Access Compliance Report

Public Rights-of-Way

(Curb Ramps)

Intersection ID: 50613	Main Street: BALSAM_BAY_RD	Cross Street: DOWNY_BIRCH_RD	Location:	N
ADA ID: 6A1CC1F23B3D	Ramp Type: Perp	Initial Pass/Fail: Fail	Overall Compliance: No	Severity Score: 22.5
Codes/Mitigation Info/Possible Solution		Field Measurements/Component Compliance

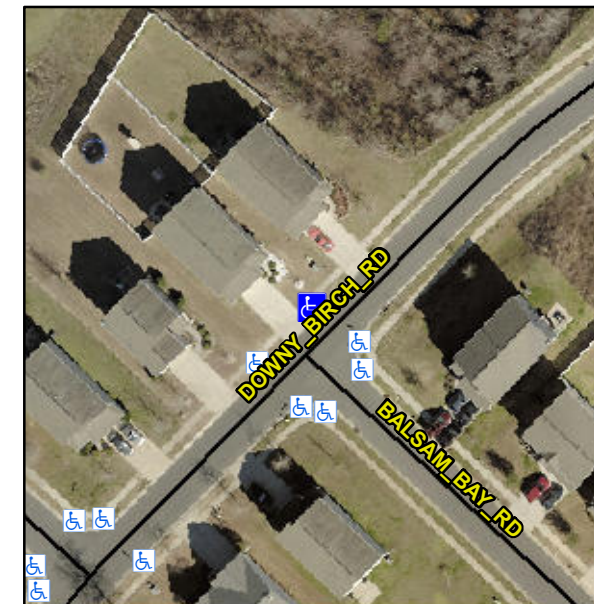
Not Found, R304.5.1, R304.2.2, R304.5.3

Compliance	Description	Data	Compliance	Description	Data
N/A	Ramp Length (in)	47.0	No	Ramp Slope (%)	9.2
No	Ramp Width (in)	47.0	No	Ramp XSlope (%)	4.5
N/A	Flare Type LT	N/A	N/A	Flare Type RT	N/A
N/A	Flare Slope LT (%)	N/A	N/A	Flare Slope RT (%)	N/A
N/A	Flare Traversable LT?	N/A	N/A	Flare Traversable RT?	N/A
N/A	Landing Length (in)	N/A	N/A	DWS Provided?	N/A
N/A	Landing Width (in)	N/A	N/A	DWS Contrast?	N/A
N/A	Landing Slope (%)	N/A	N/A	DWS Length (in)	N/A
N/A	Landing X Slope (%)	N/A	N/A	DWS Full Width?	N/A
N/A	Landing Curb? (Y/N)	N/A	N/A	DWS Offset (in)	N/A
N/A	Shared Landing?	N/A			
N/A	Gutter Ponding?	N/A	N/A	Gutter Slope (%)	N/A
N/A	Gutter Lip Ht (in)	N/A	N/A	Gutter X Slope (%)	N/A
N/A	Painted X Walk1?	No	N/A	Painted X Walk2?	N/A
	X Walk 1 Direction	To SE		X Walk 2 Direction	N/A
N/A	X Walk 1 Width (in)	N/A	N/A	X Walk 2 Width (in)	N/A
	X Walk 1 Slope (%)	3.5		X Walk 2 Slope (%)	N/A
	X Walk 1 X Slope (%)	3.8		X Walk 2 X Slope (%)	N/A

Remove & Replace Entire Ramp.
